**RE: 4 DELMAR PARADE AND 812 PITTWATER ROAD, DEE WHY
ADDENDUM TRAFFIC REPORT**

A development application (DA) has been submitted to Northern Beaches Council (Council) for a proposed mixed-use development at 812 Pittwater Road & 4 Delmar Parade, Dee Why.

Following post-submission consultation with Council, modifications have been made to the development, including a minor variation to the development yields and the following key changes relating to traffic and parking:

Figure 1: Indicative Traffic Management Plan

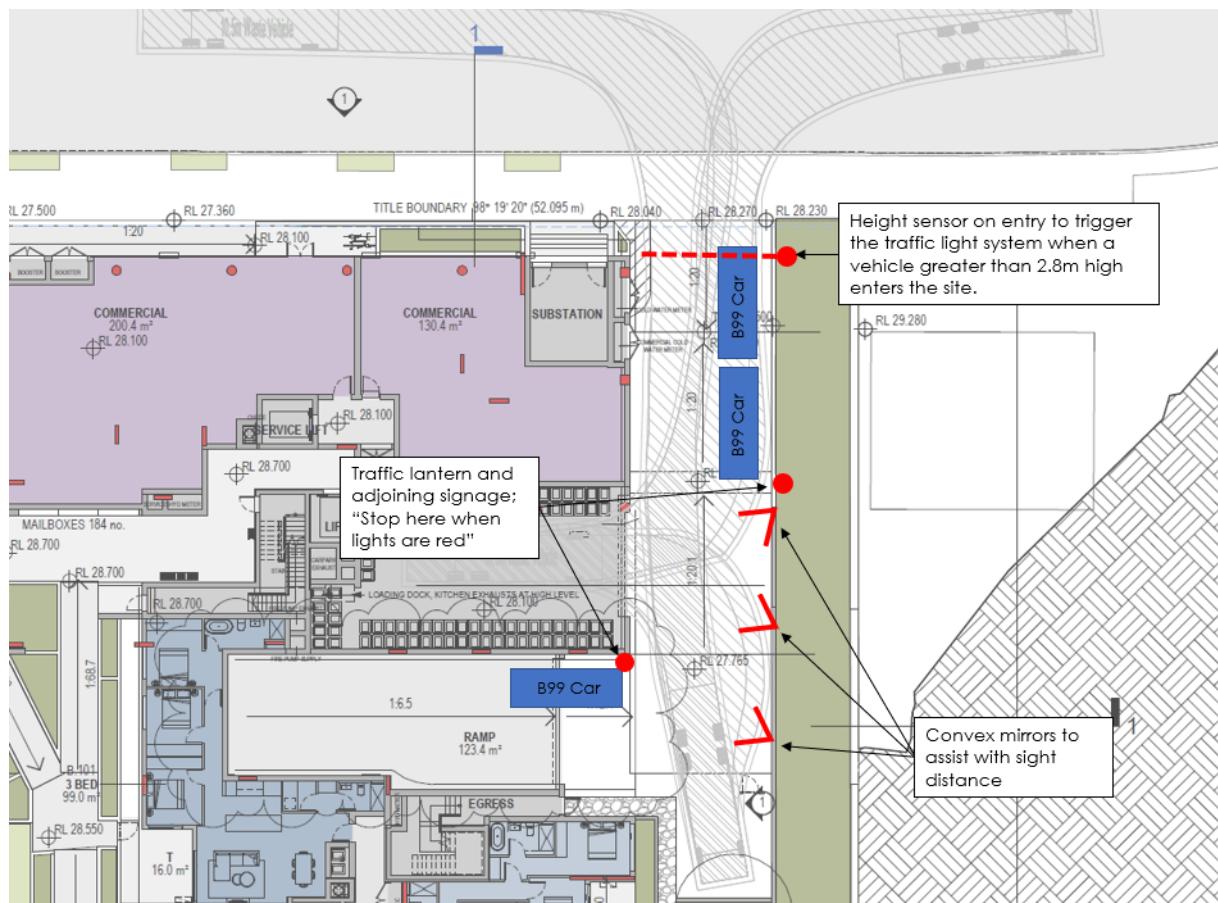
A traffic management plan is to be implemented to manage the access of heavy vehicles including SRVs and above. The traffic management plan would include the following measures:

- A height sensor is to be installed across the driveway which triggers the traffic management system when a vehicle greater than 2.8m high enters the site.
- A button is to be located within the loading dock, for drivers to trigger the traffic management system on exit.
- Traffic lanterns at two hold points (on entry and exit) a light (red or flashing depending on the chosen system), with an adjoining signage which says "Stop here when lights are red/flashing".
- On entry, the hold point is to be located at least 12m from the site boundary to enable a queue of up to two vehicles from the traffic lantern.
- On exit, the hold point is to be located at the top of the 1:12 grade ramp.
- Convex mirrors are to be placed such that:

- On the ground level:
 - ▶ Trucks exiting the loading dock are able to look out of cars entering the site from the left and exiting the site from the right, and
 - ▶ Cars exiting the basement are able to look out for entering trucks and cars.
 - In basement level 1:
 - ▶ At the bottom of the ramp and at all corners along the route of travel to the basement loading bay. This is to ensure visibility between small trucks and opposing cars at corners where swept paths are constrained.

An indicative plan of the traffic management measures on the ground floor is presented in Figure 1.

rawing No. / **TP01.01 C**

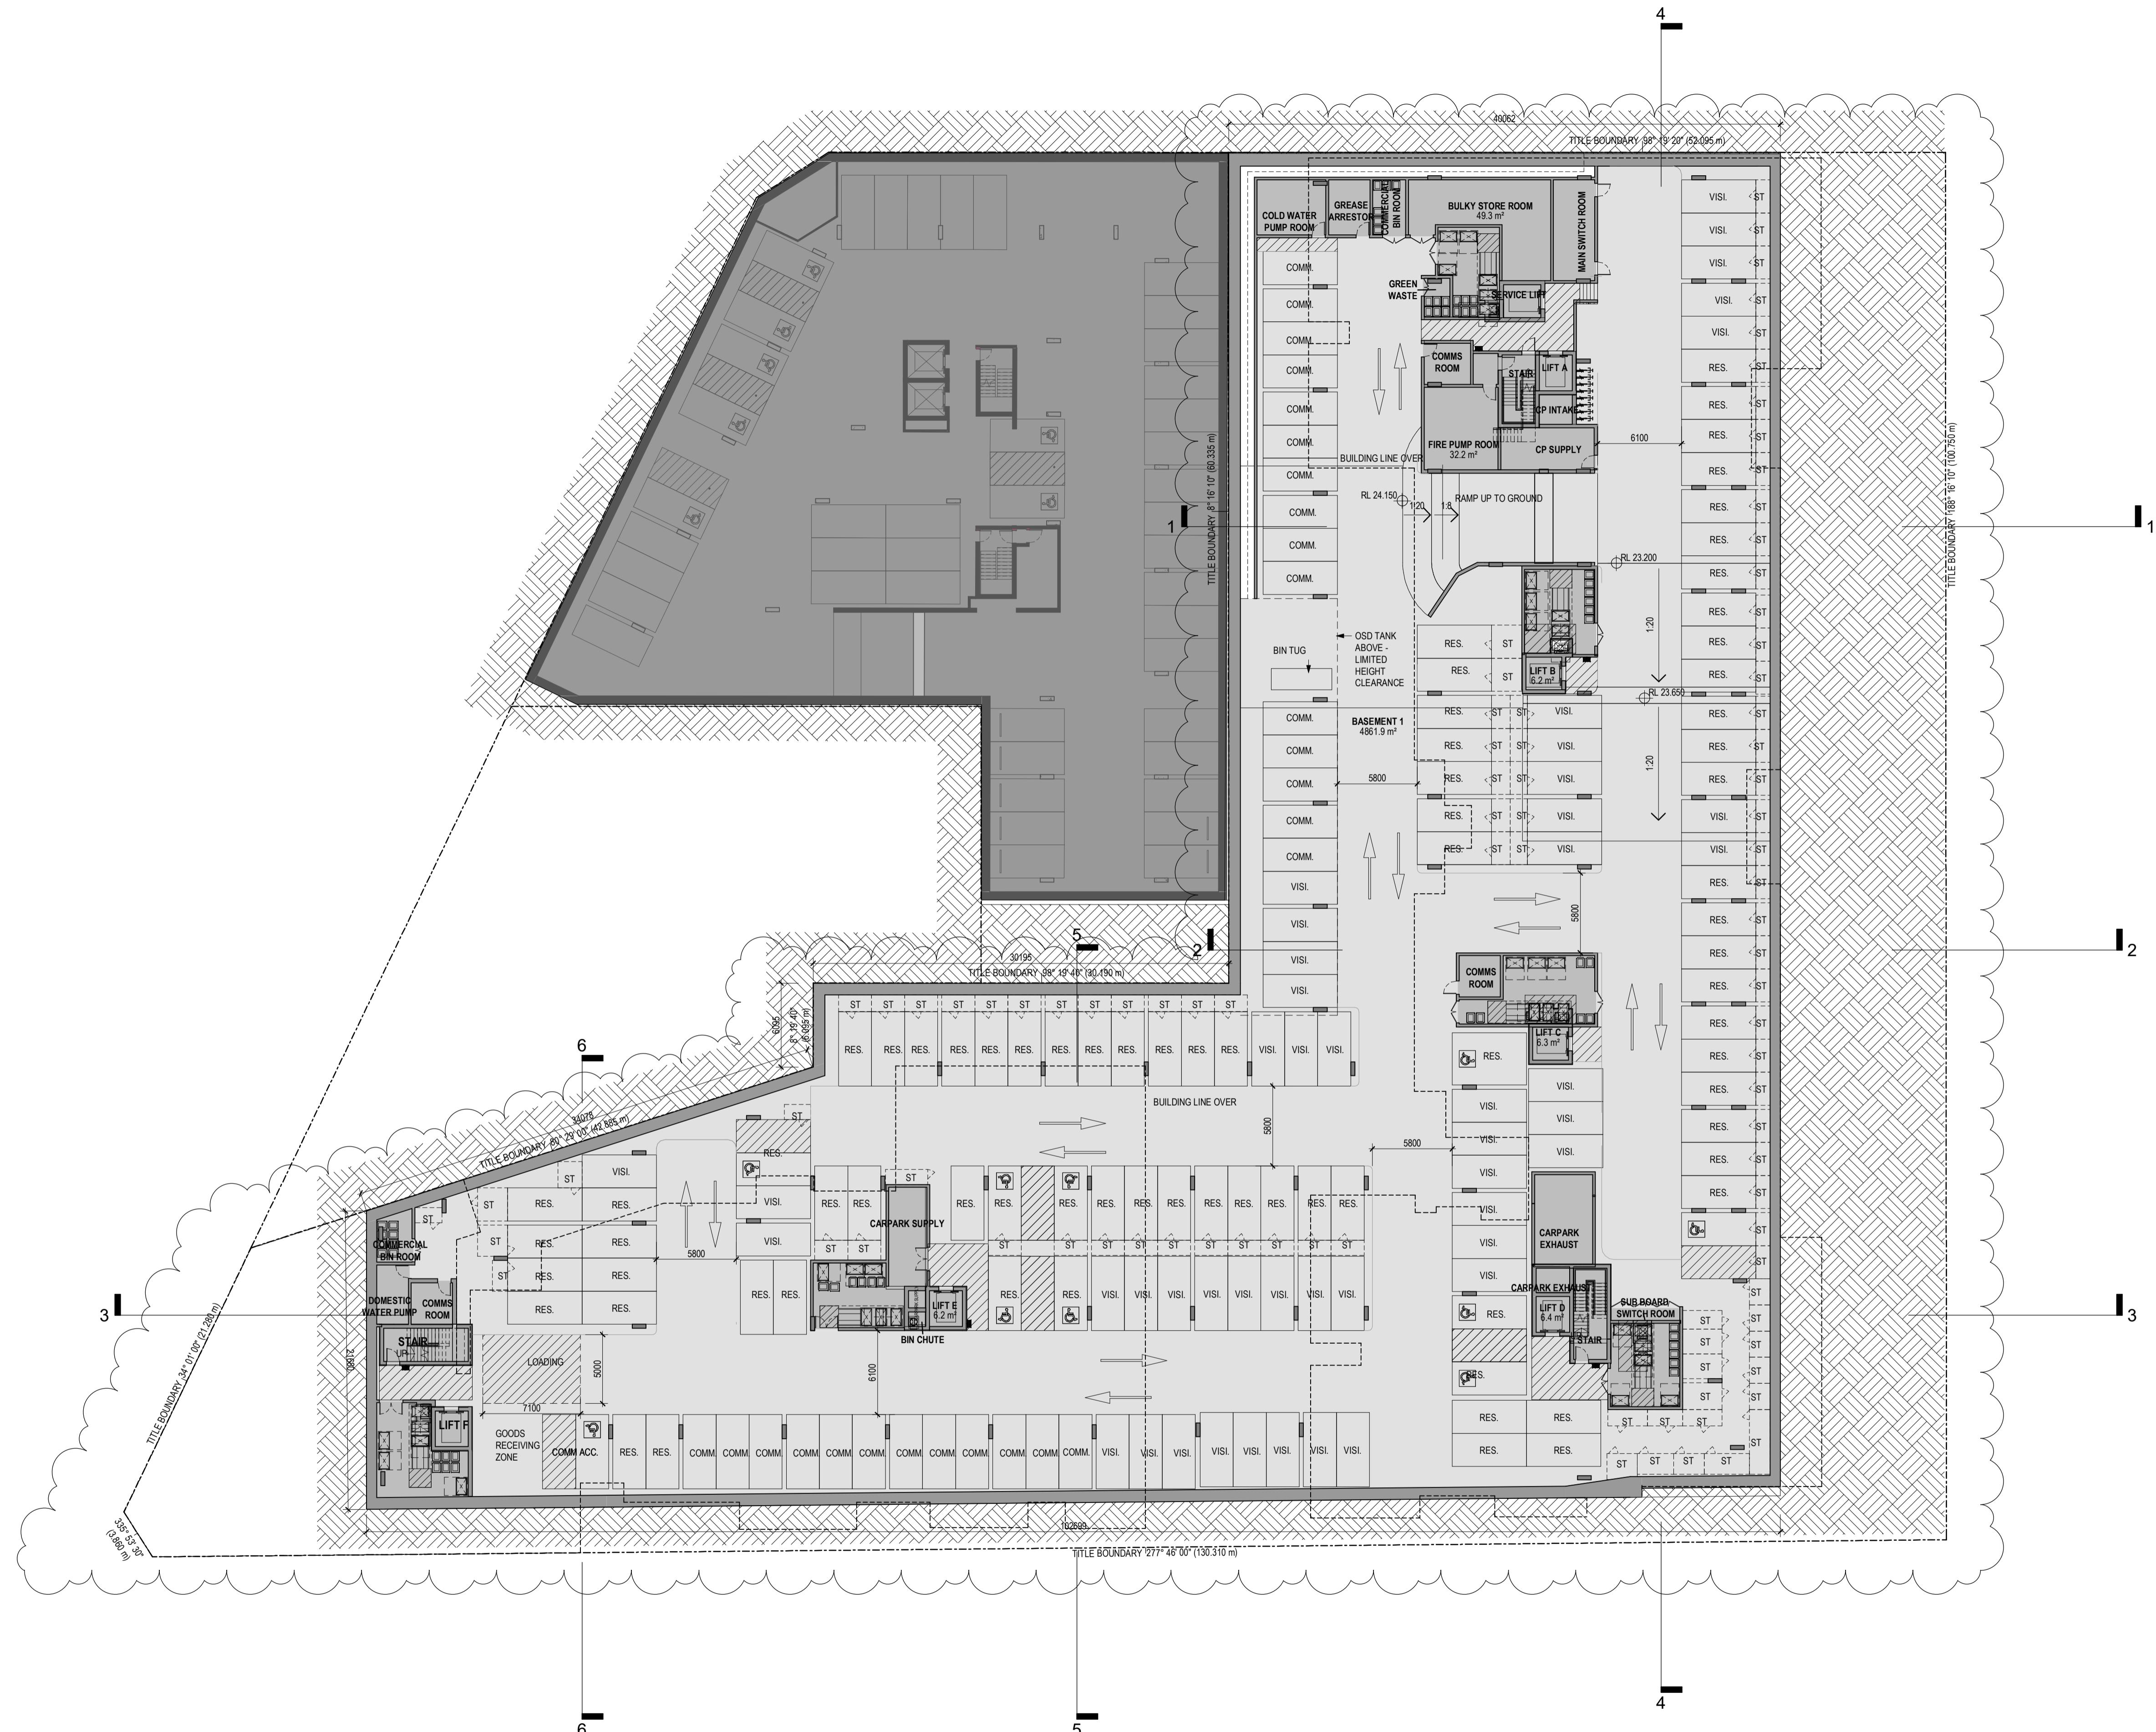
- a 7.1m long loading bay to accommodate a 6.4m long Small Rigid Vehicle (SRV) has been provided in basement level 1
- basement level 1 has been modified to accommodate ramp grades and headroom appropriate for an SRV.

RAMP GRADE PROPOSAL - GROUND LEVEL TO BASEMENT 1
AS2890.2 6.4m SMALL RIGID VEHICLE

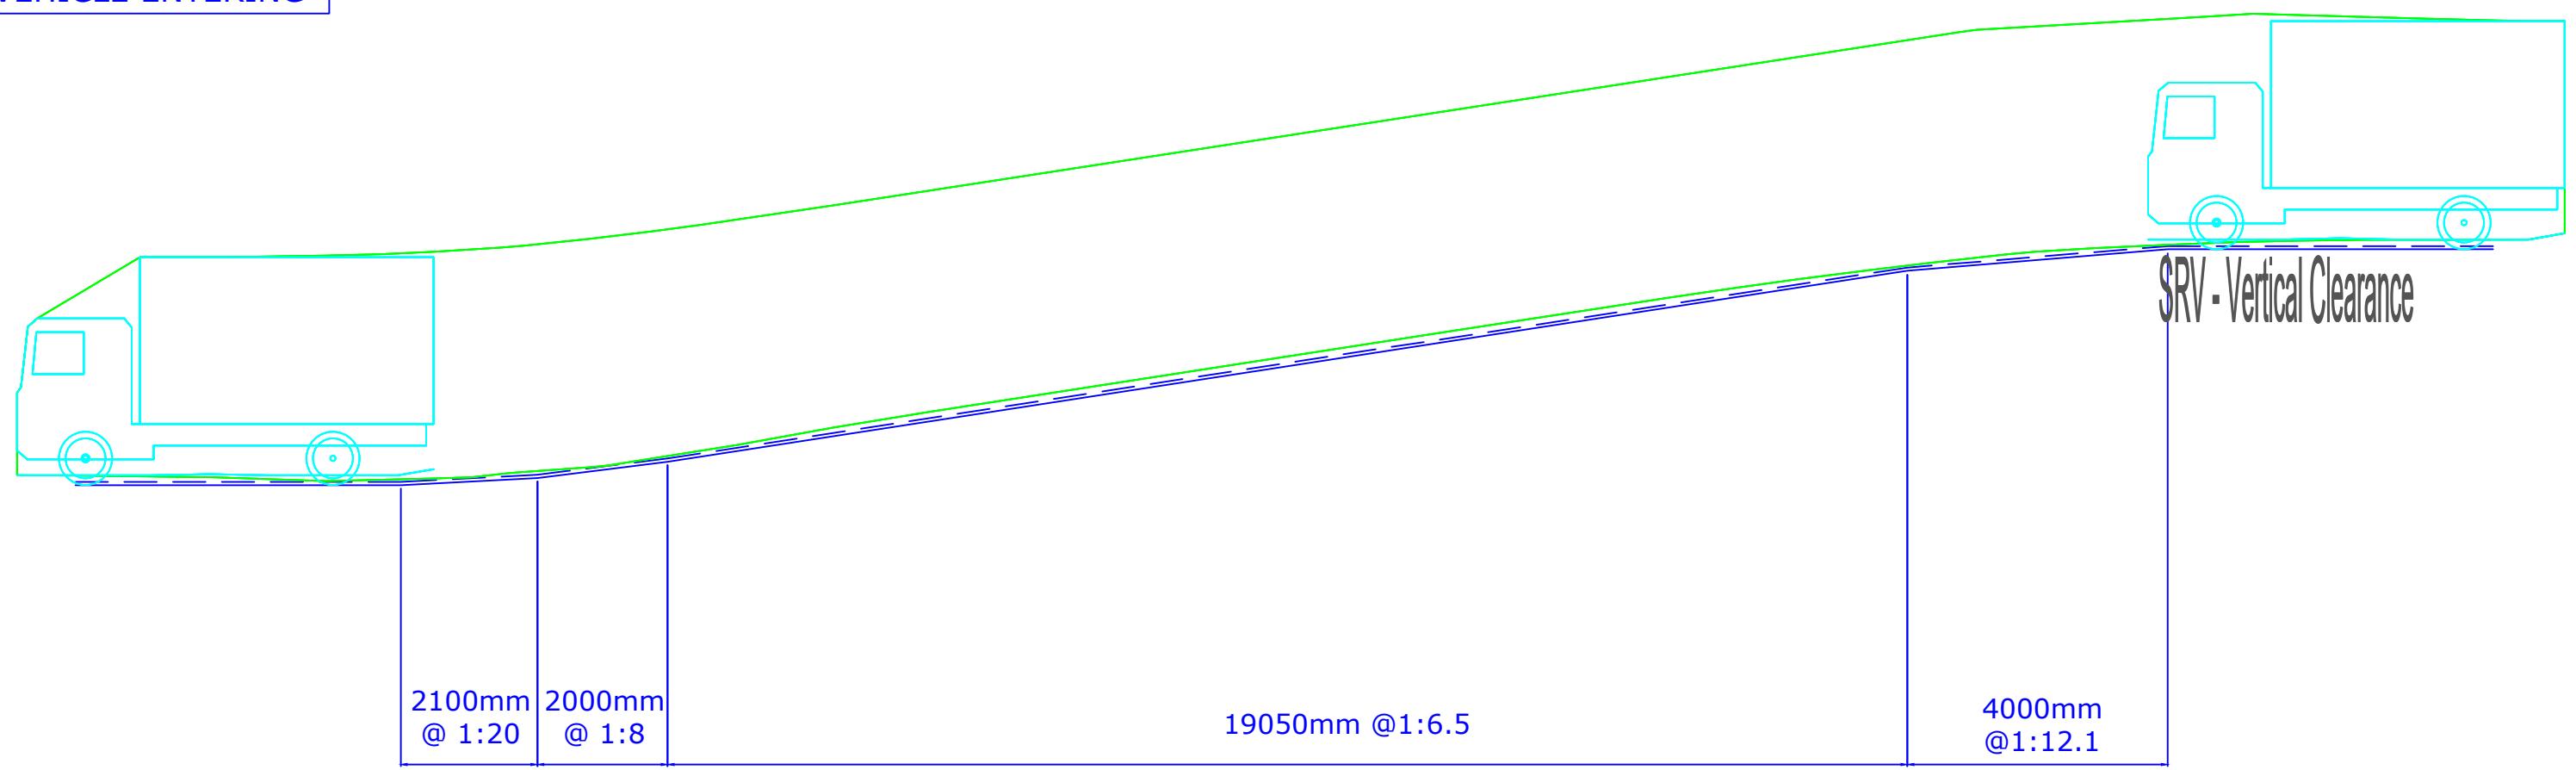
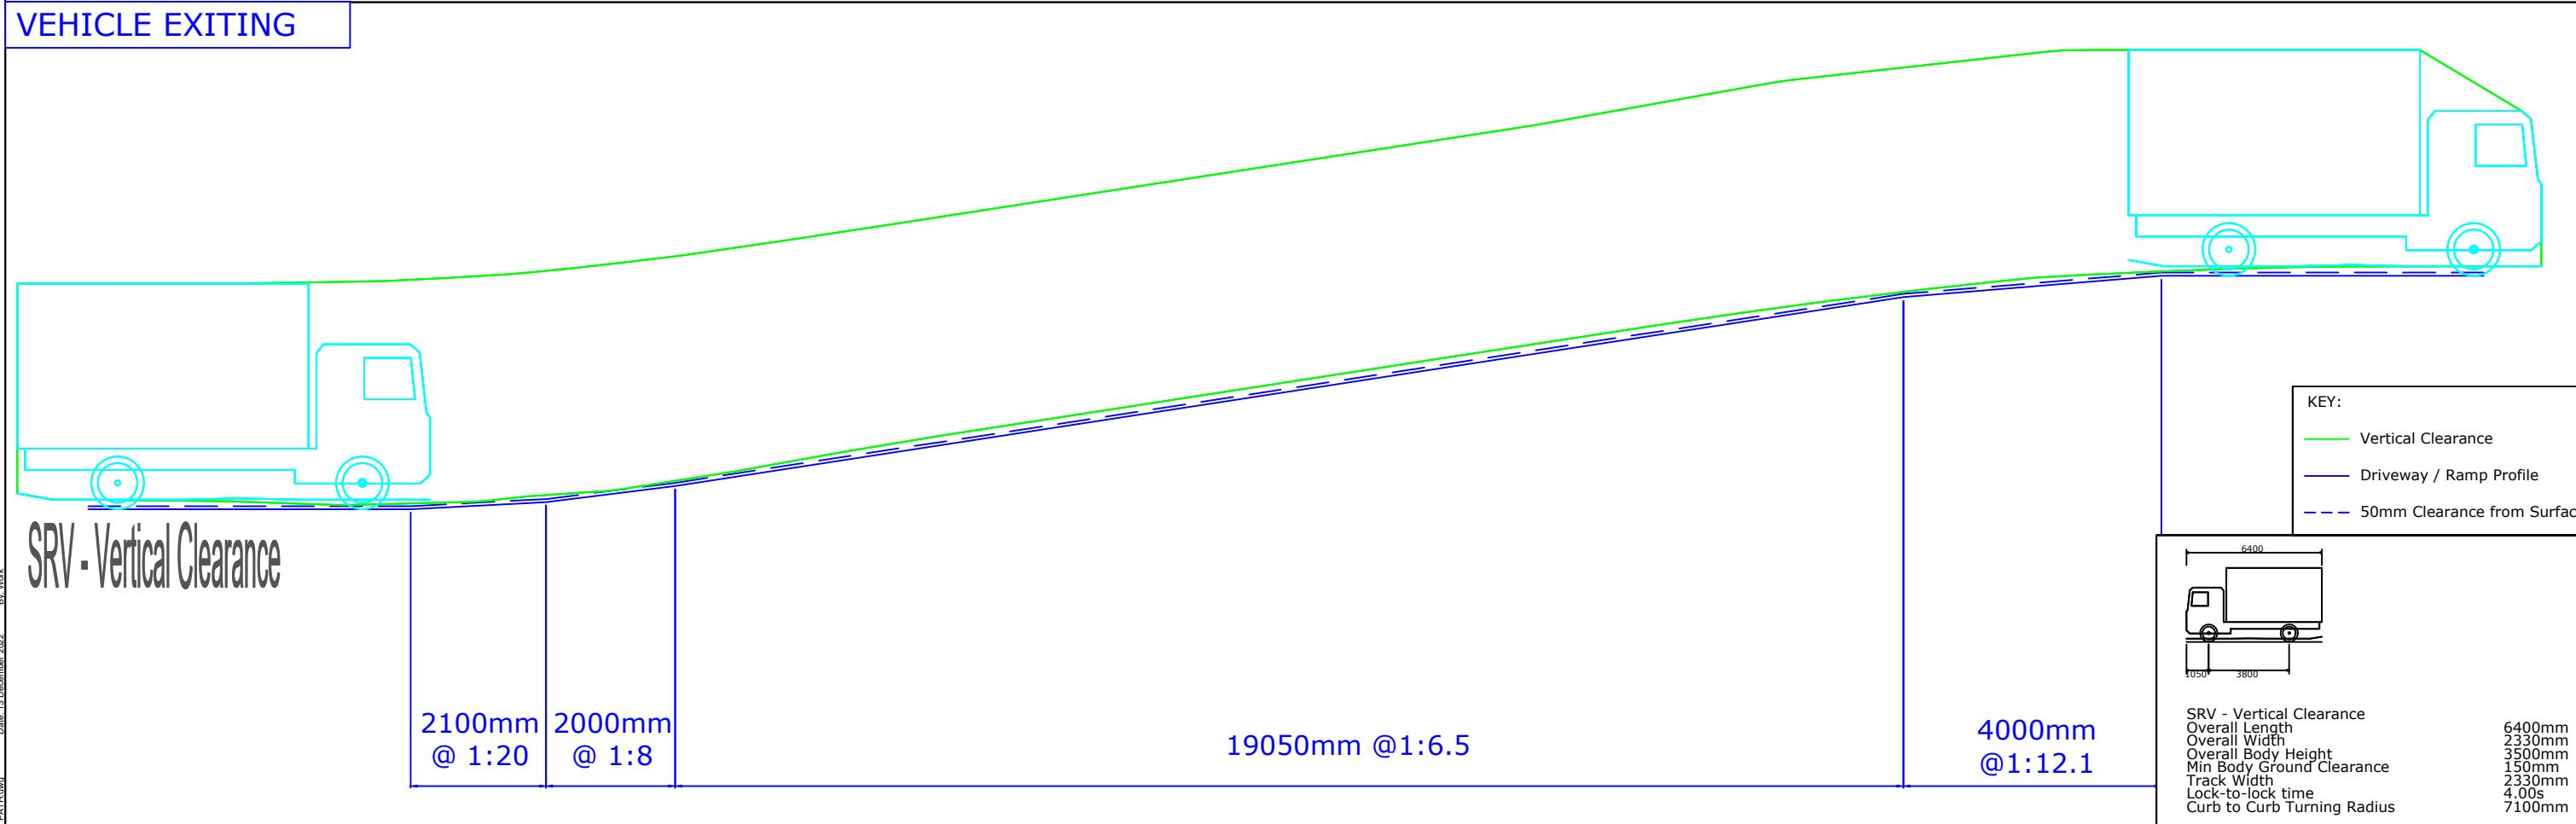
- a maximum grade of 1:6.5 and change in grade of 1:12 for SRVs
- a maximum grade of 1:4 and change in grade of 1:8 for B99 vehicles
- a maximum grade of 1:20 for car parking modules
- a maximum grade of 1:25 for a service bay.
